Addendum No. 006  
Date: February 28, 2023  
Project: City of Great Falls Civic Center Partial HVAC Renovation  
Architect: Cushing Terrell ■ 219 2<sup>nd</sup> Ave South ■ Great Falls, MT 59405 ■ (406) 452-3321  
To: All Plan Holders of Record  
Pages: 107 pages total: 105 (8 1/2x11); 0 (11x17); 2 (24x36 sheets)

**City of Great Falls Civic Center Partial HVAC Renovation**

#### PROJECT IDENTIFICATION:

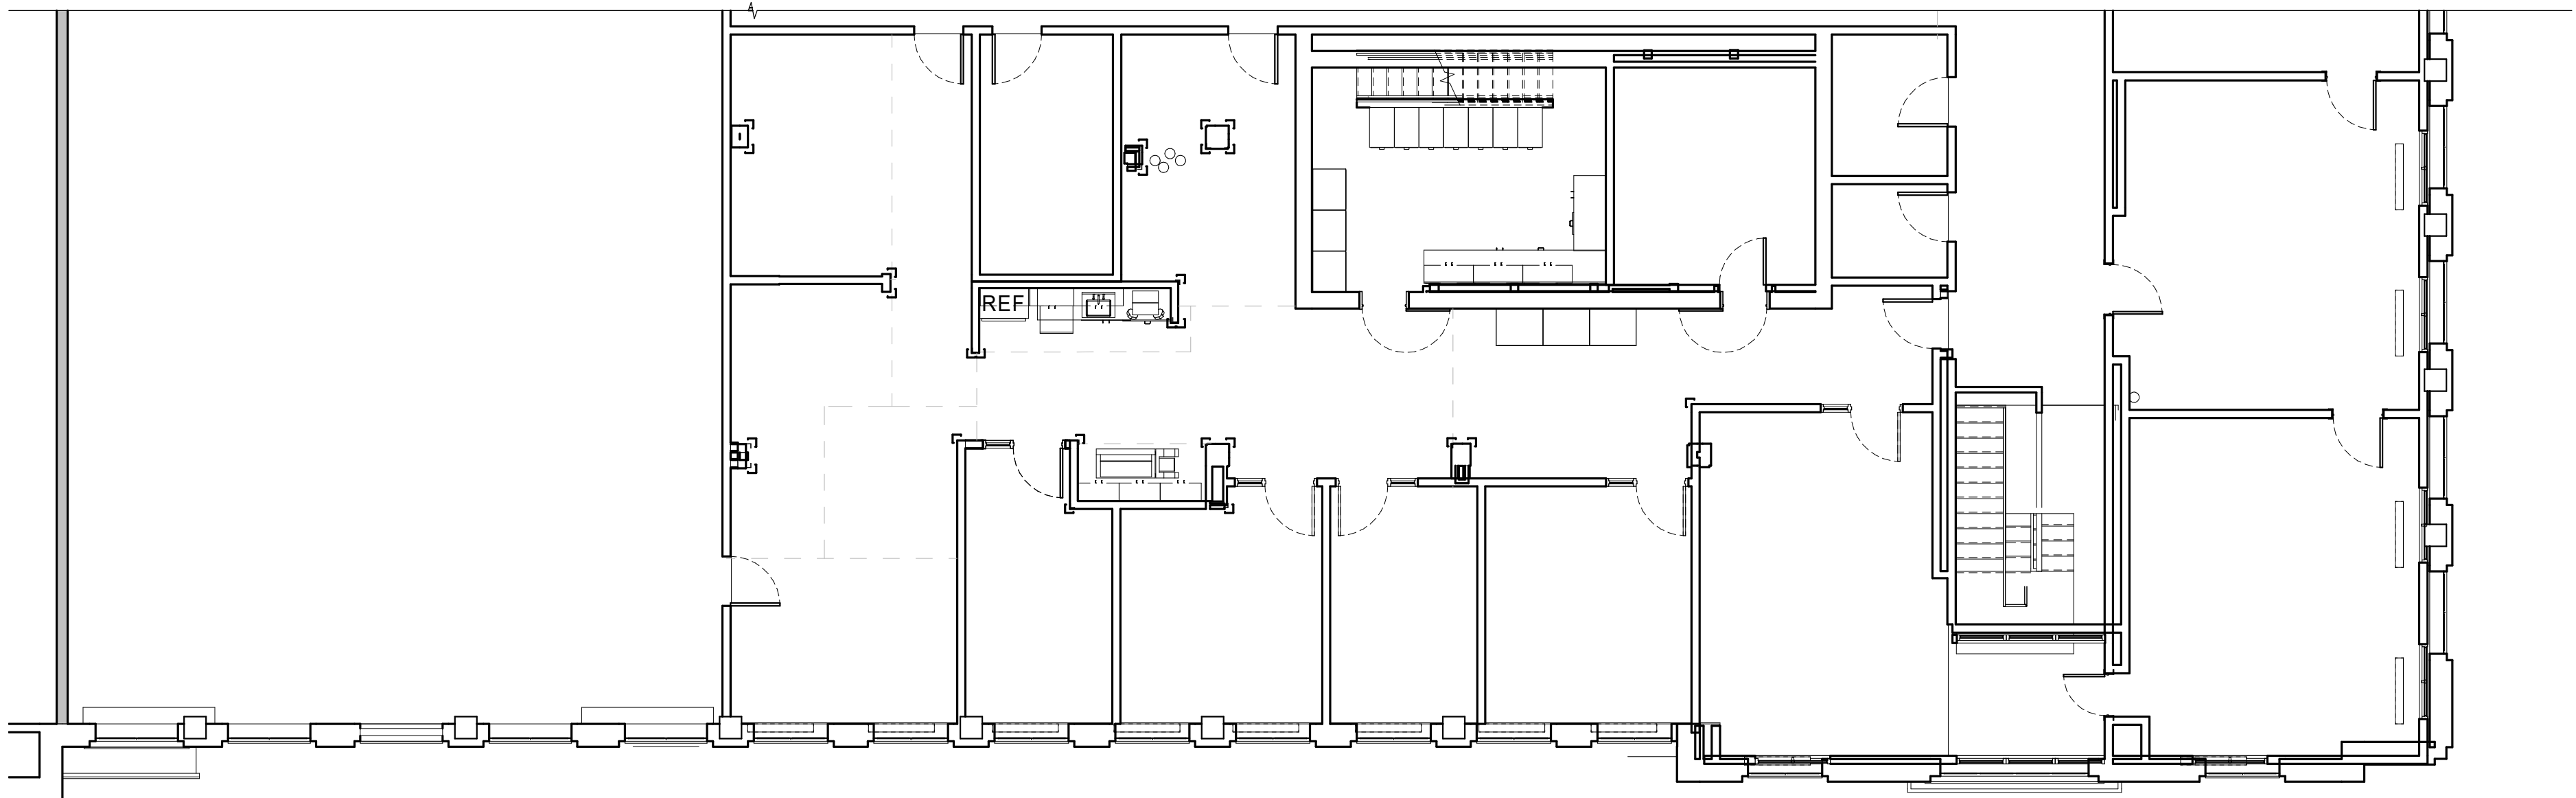
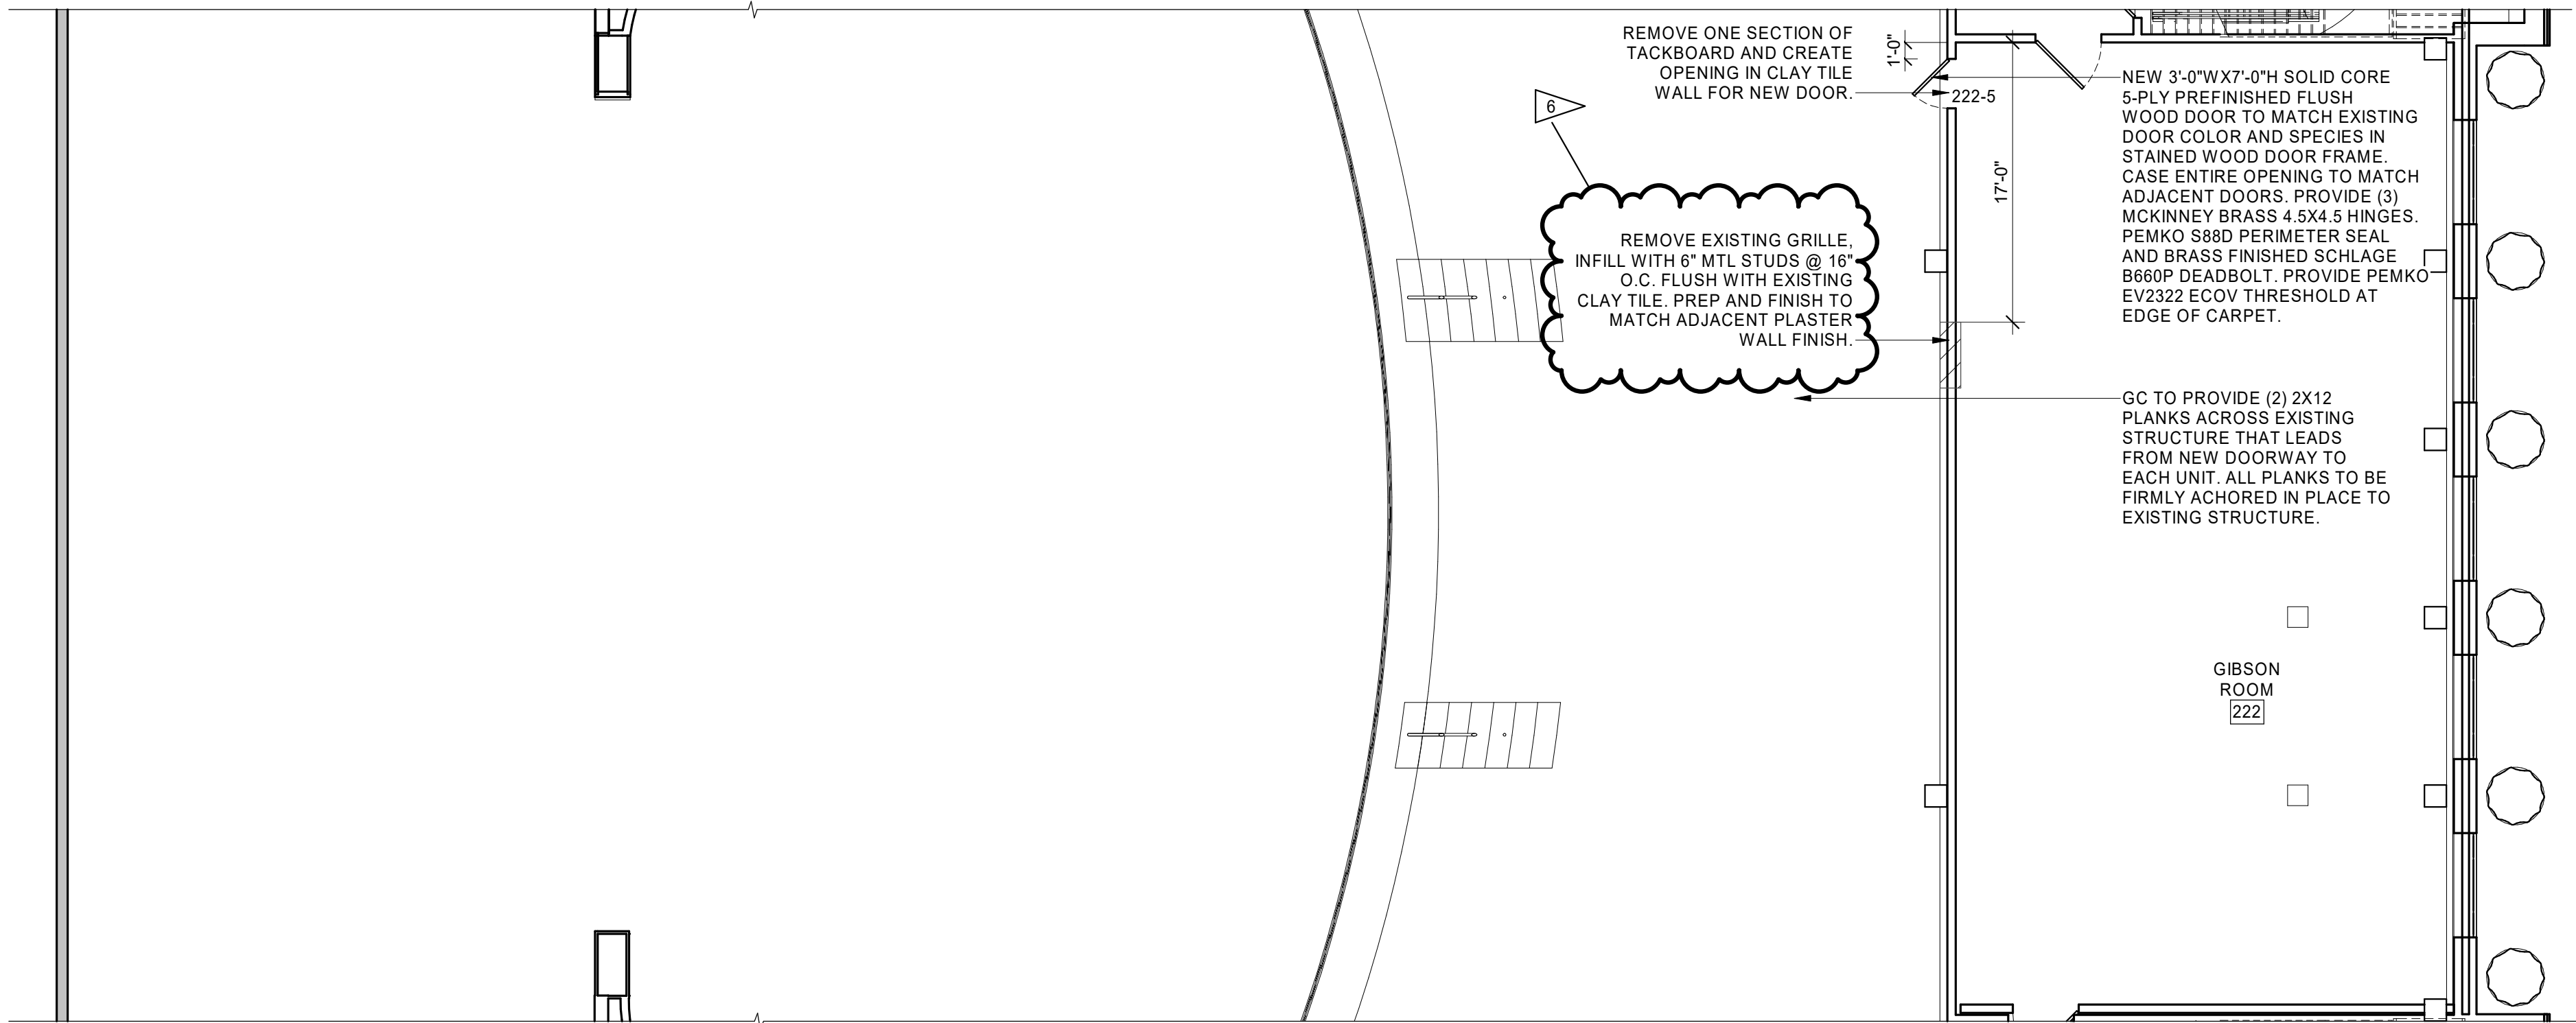
Gypsum wallboard patch in two locations has been modified to indicate plaster to match existing adjacent construction.

## SOFFIT SECTION DETAIL

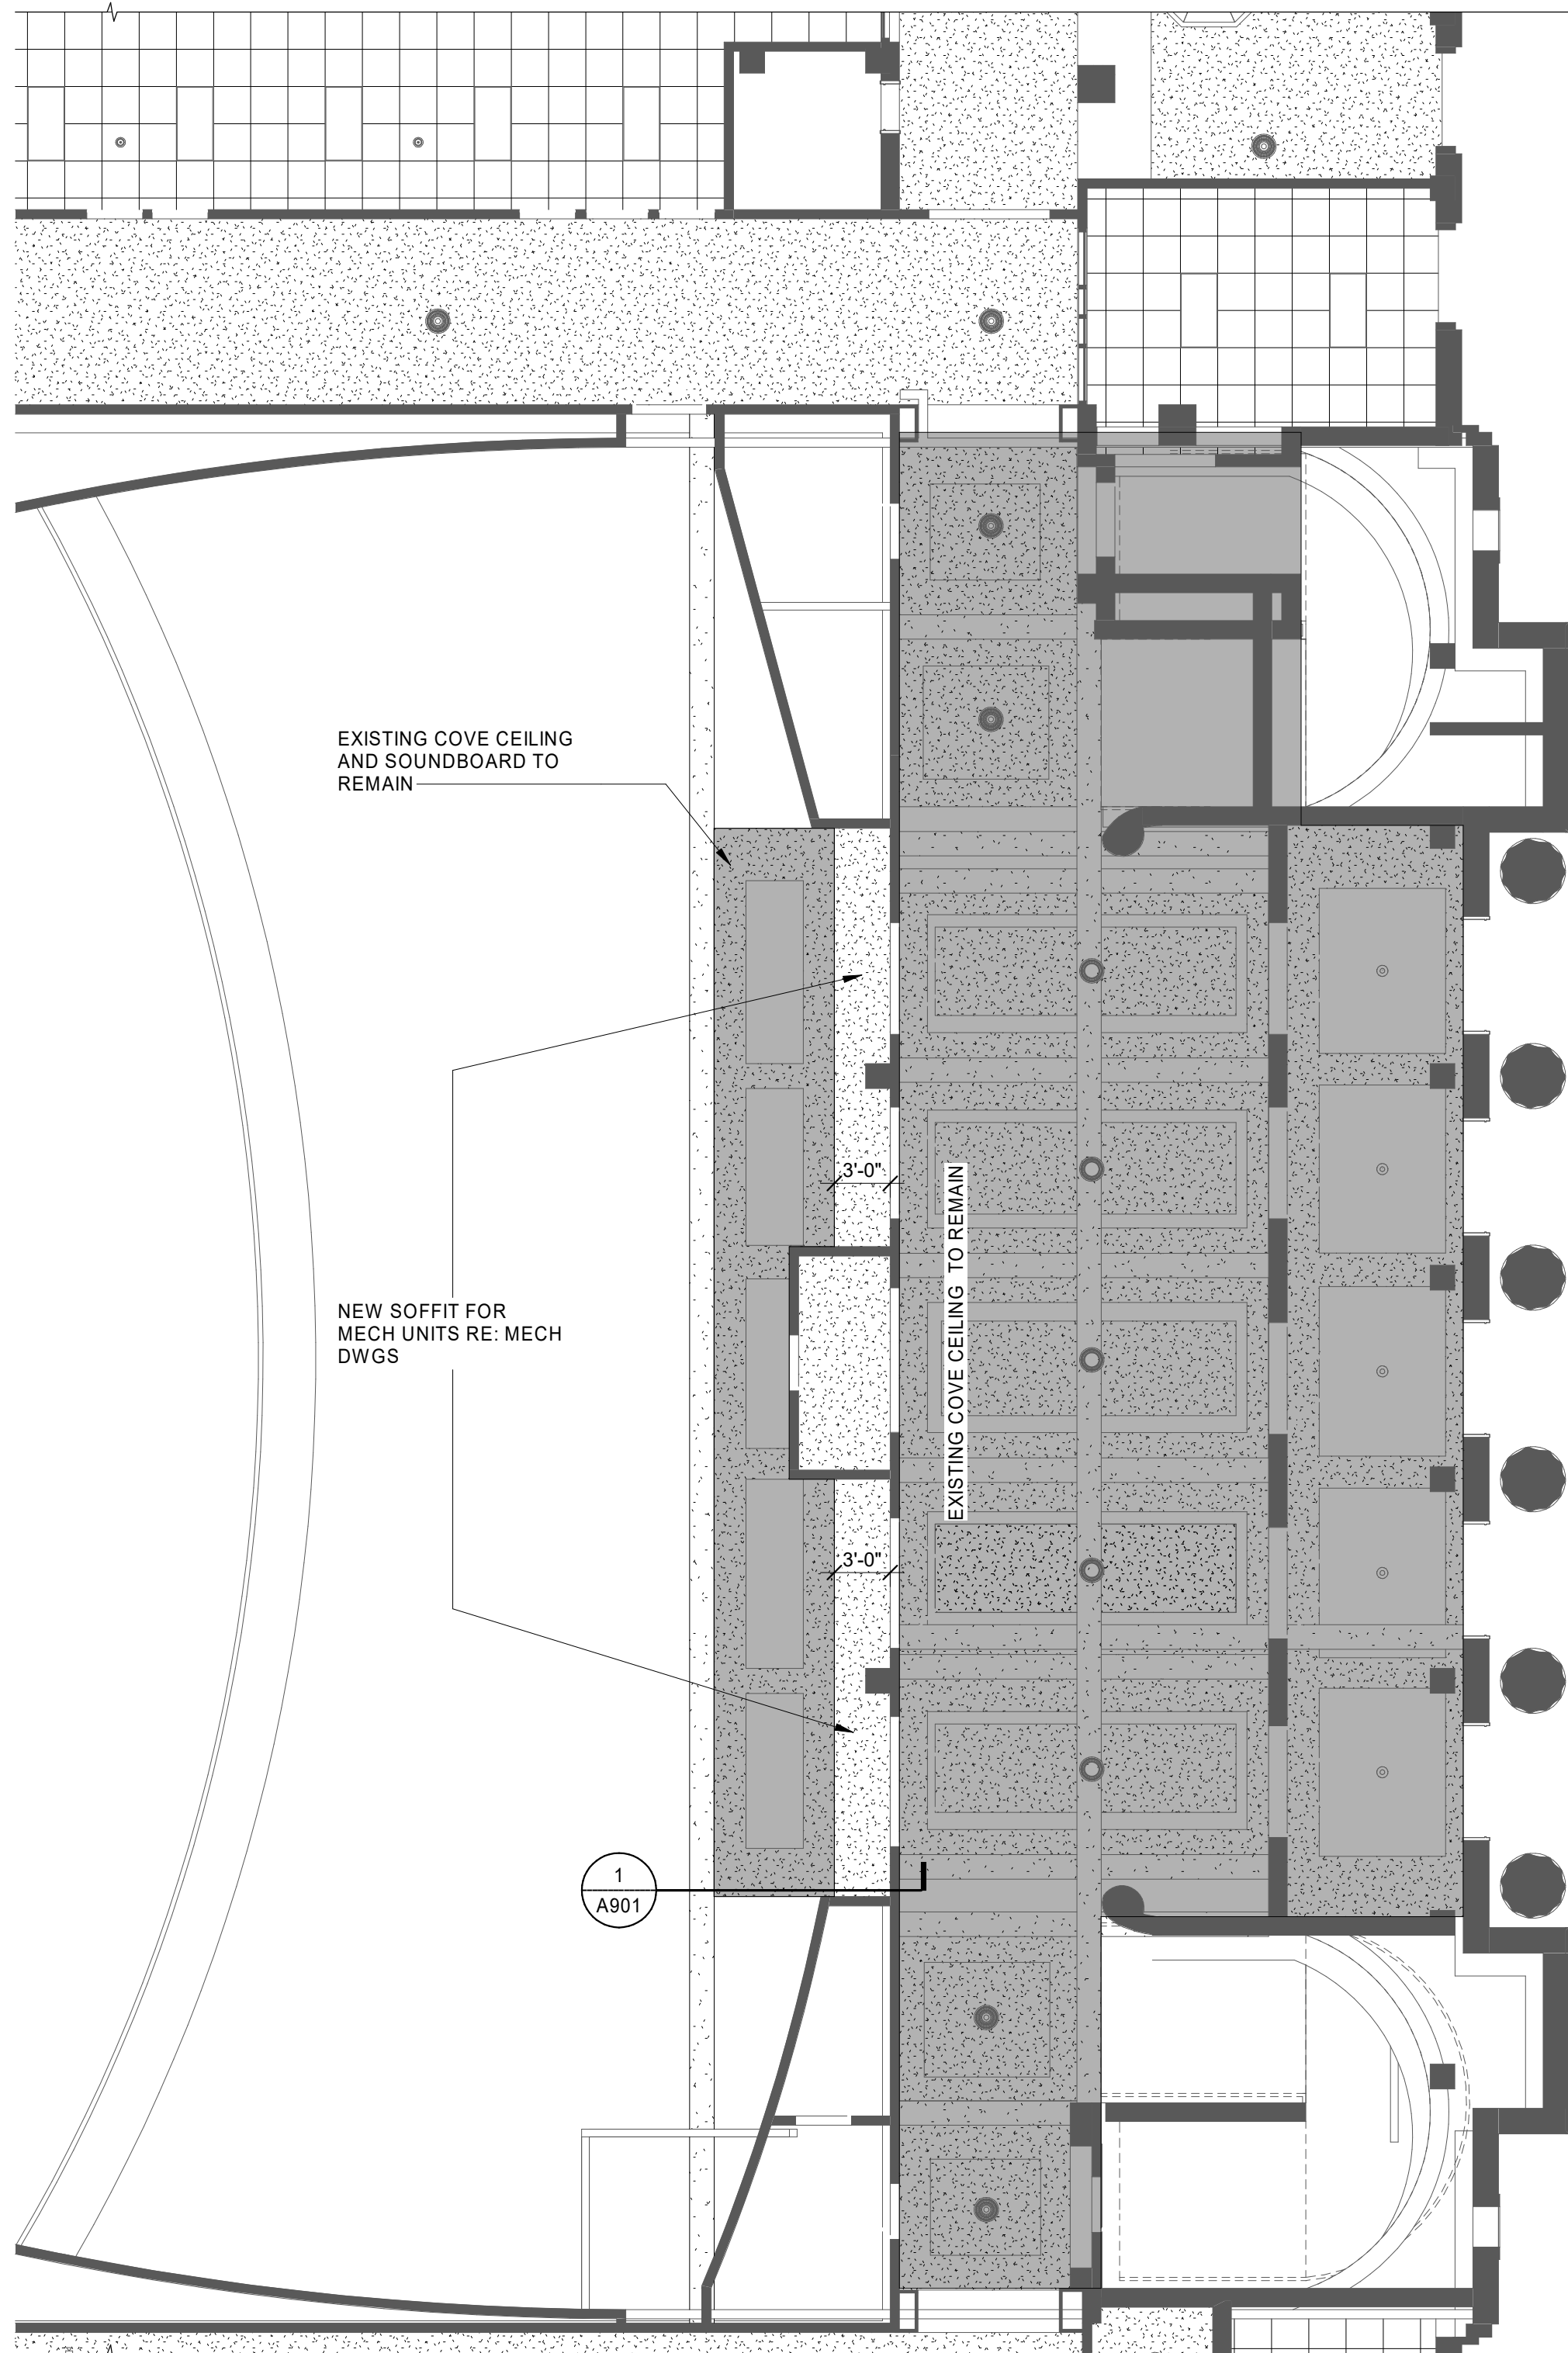
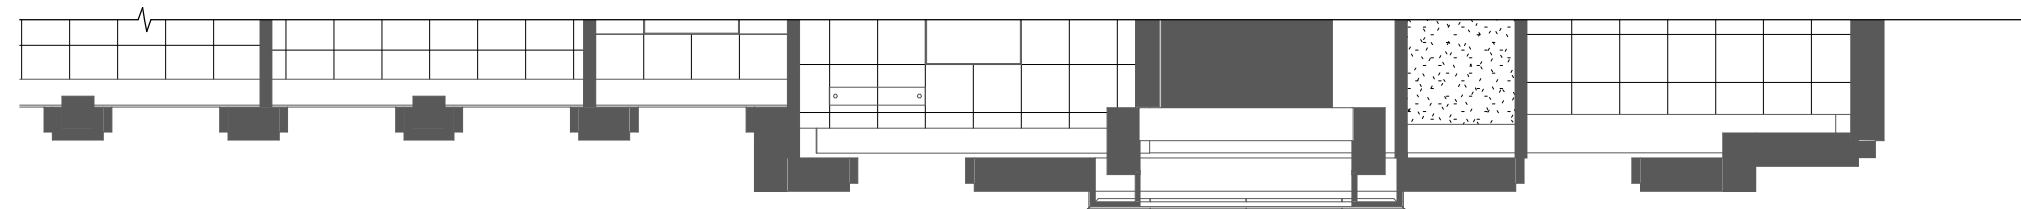
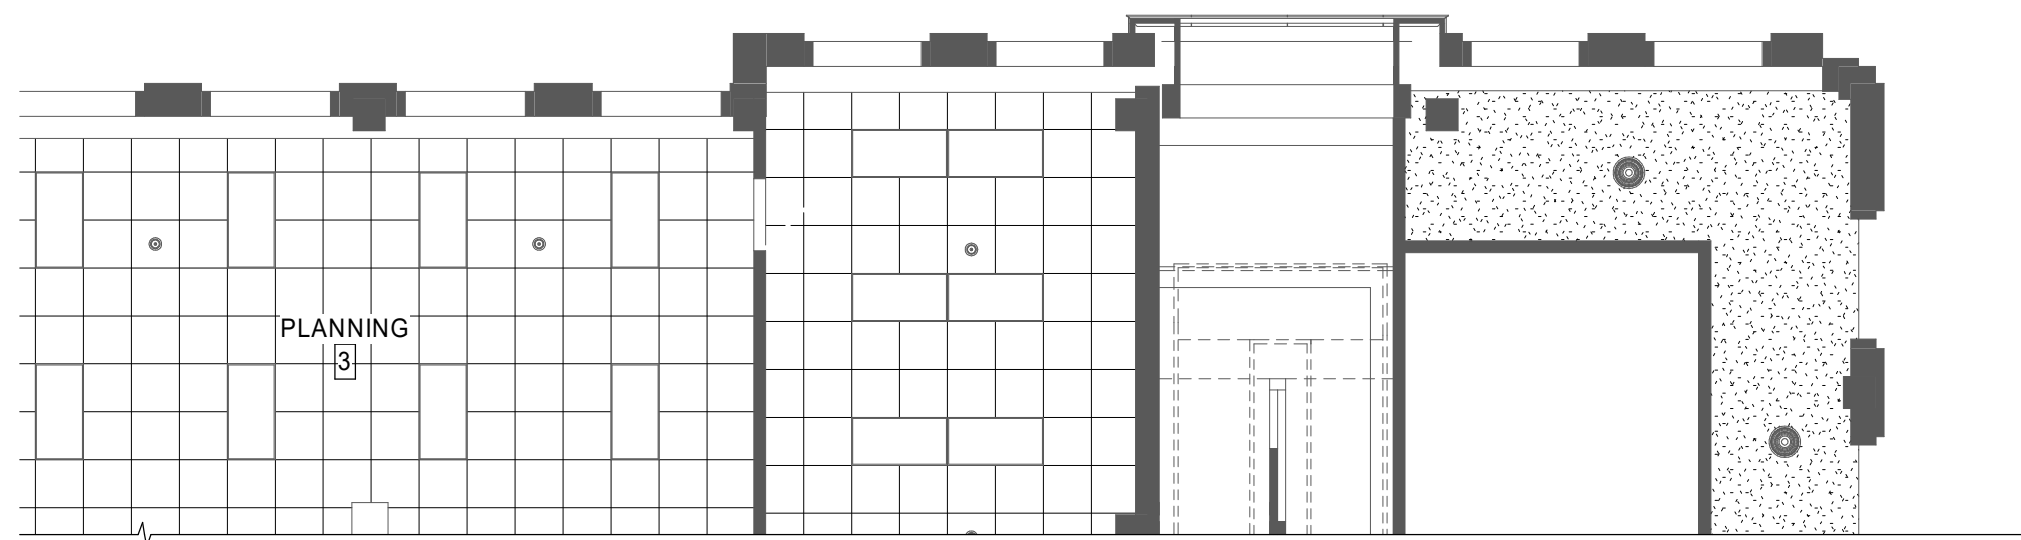
Soffit and Crown Moulding construction has been modified to indicate materials to match existing wall and ceiling construction.
